Modified Well Design 4/29/20

ELIZABETH SWD FED 2

WELL BORE DATA SHEET

Subject: RE: Elizabeth SWD No. 2 well design

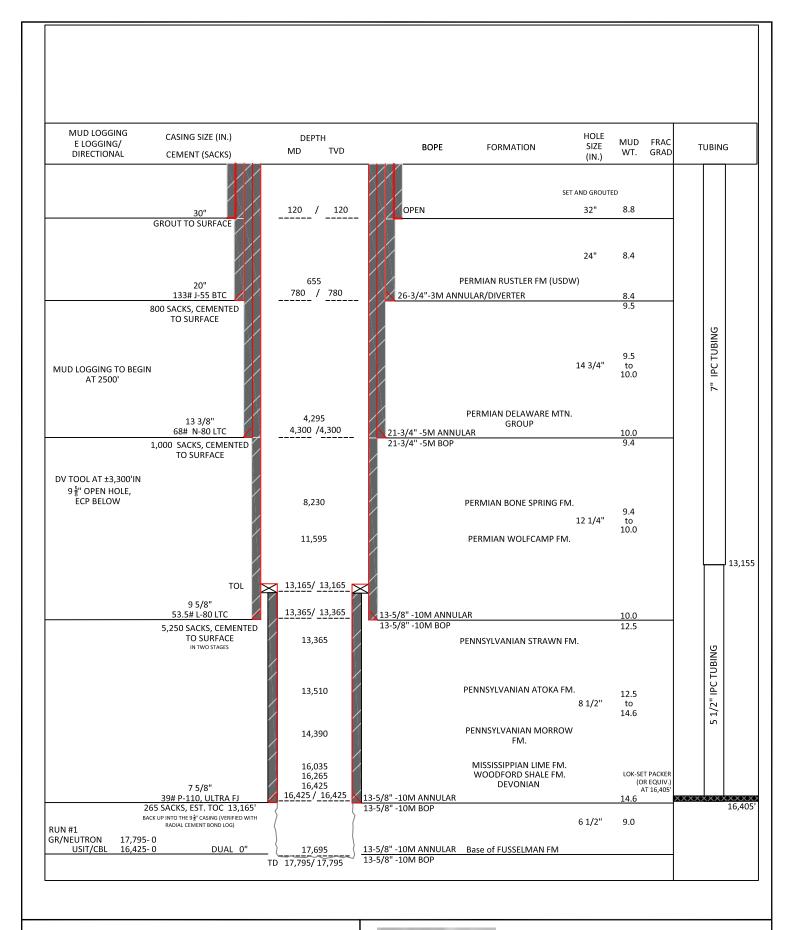
Blackbuck decided to increase their tubing size. Attached is a revised Wellbore Diagram reflecting the use of 7"x5-1/2" IPC Tubing inside 9-5/8" casing and 7-5/8" liner.

Would Blackbuck like to append its initially proposed well and casing design?

Also, if the anticipated tops of the Woodford and Mississippian Limestone intervals could be included, that would help me complete the technical review.

Noted,

Thanks. I will update the application.
